UPDATES TO THE 2018 DISCUSSION GUIDE & PUBLIC COMMENT AGENDA

2018 ICC CODE DEVELOPMENT CYCLE TECHNICAL UPDATES TO THE 2018 PUBLIC COMMENT AGENDA FOR THE PROPOSED CHANGES TO THE:

SUMMARY OF UPDATES:

3114.8.5.3(1)
Bracing Unit Distribution--Maximum Linear Length

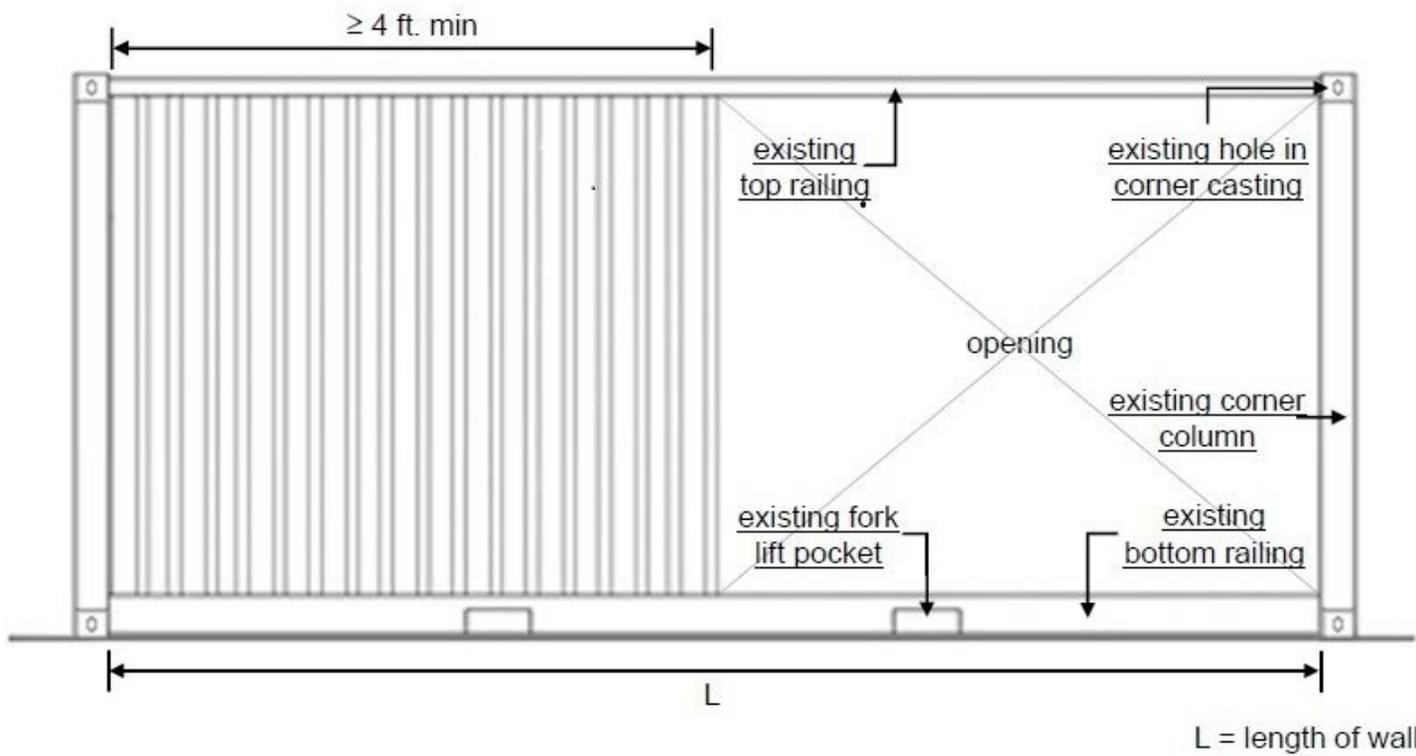
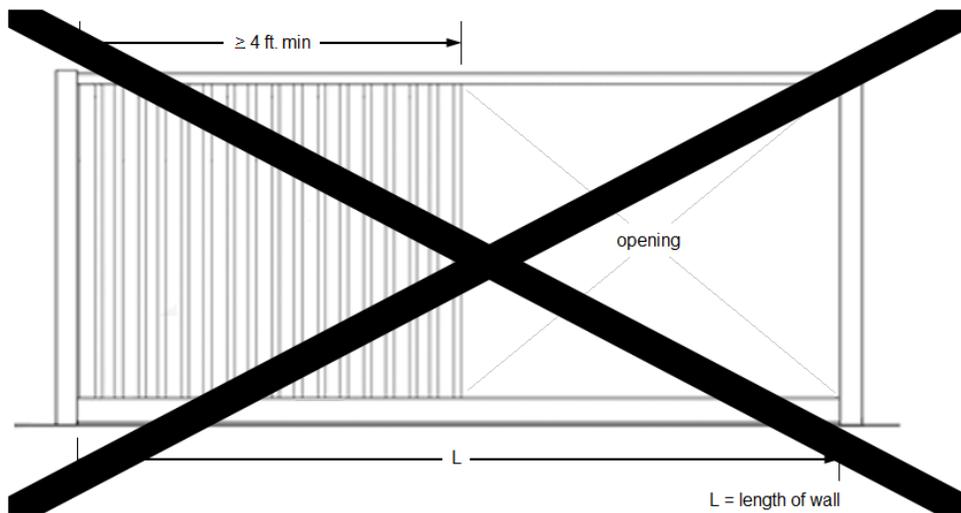
G151-18: Images missing from Public Comment 2
